NEW GARAGE & OUTBUILDING ON 3 OF THE FARM
DUIKERFONTEIN NO 785 FOR S.B. OOSTHUIZEN

CITY HEALTH DEPT. DURBAN
PLAN NO. 8/5/09
RECEIVED 12 MAY 1959
APPROVED

CITY OF DURBAN
PLAN NO 8/5/09
APPROVED
C.G. HANDS
CITY ENGINEER

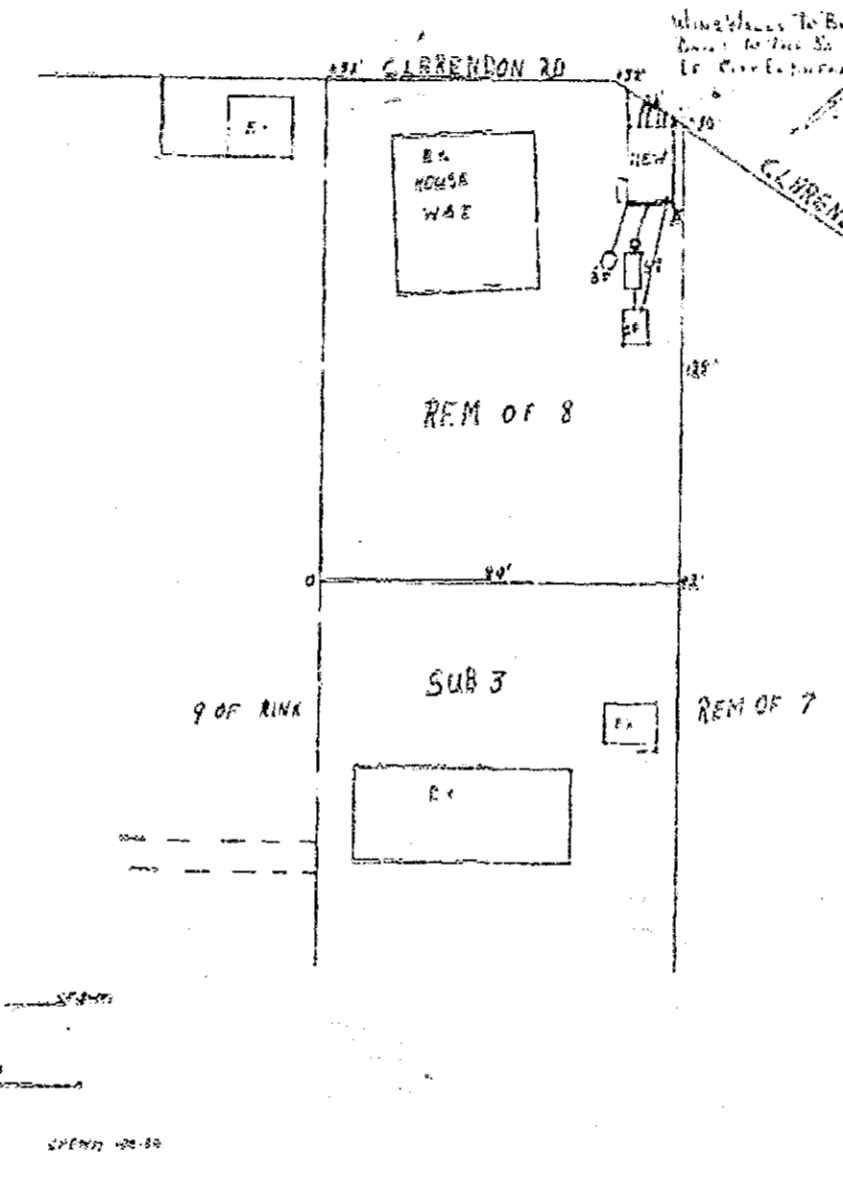
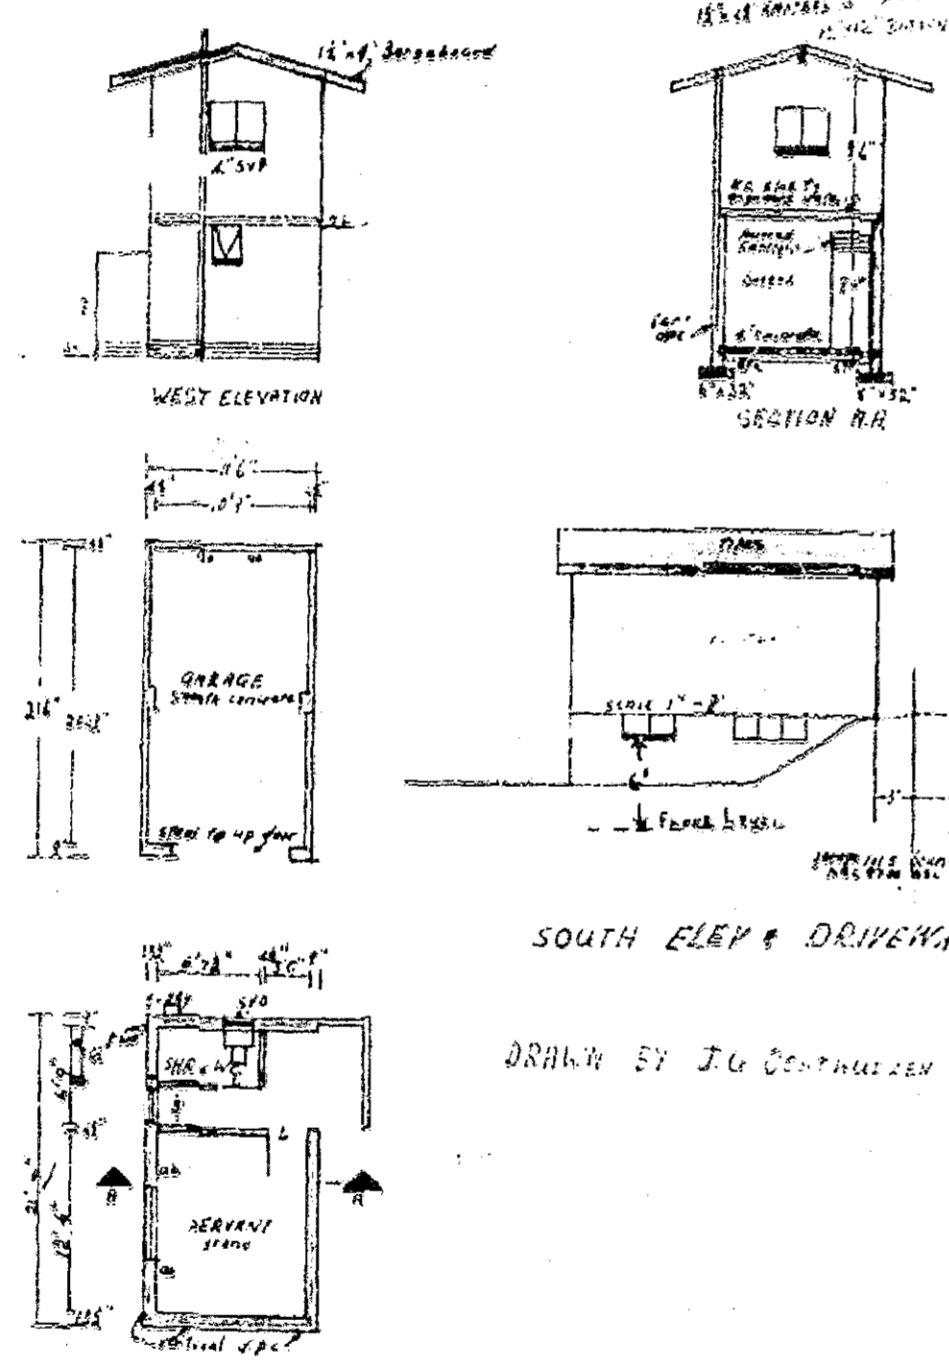
B.
29 Clarendon Rd.
off steps to dug.

H.C. DETAILS REQUIRED
FOUNDATION LEVEL REQUIREMENTS
FOR FOUNDATIONS OF ANY FRONTAGE BLDGS TO BE AT
7" BELOW THE LEVEL OF THE ROAD, VERGELAND AND
SIDE ENTRANCES ON THE ROAD SIDE, UNLESS
IT IS CONSTRUCTED ON THE SAME CHAMP AS THE ROAD IN
POSSIBLE, AND AT A LEVEL.

ALL SOAK PITS 170' FROM
BUILDINGS OR BOUNDARIES
PUMPING INSPECTOR
PLAN APPROVED
SEWERAGE FEES
Connection Fee
Inspection Fee
